PRODUCT CHANGE NOTIFICATION

Ref Nr: EBR-0176-22071804

To improve the welding performance of products, change the dimension of bottom conductor.

Effect on Yageo PN: RC2512, AC2512, SR2512, RV2512

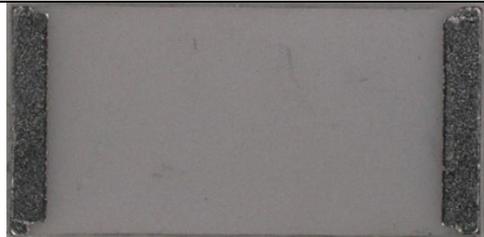
Before change	After change
R-value	All	All
Dimension in datasheet	0.50 ± 0.20	0.60 ± 0.20
Product appearance-back

REASONS: To improve the welding performance of products.
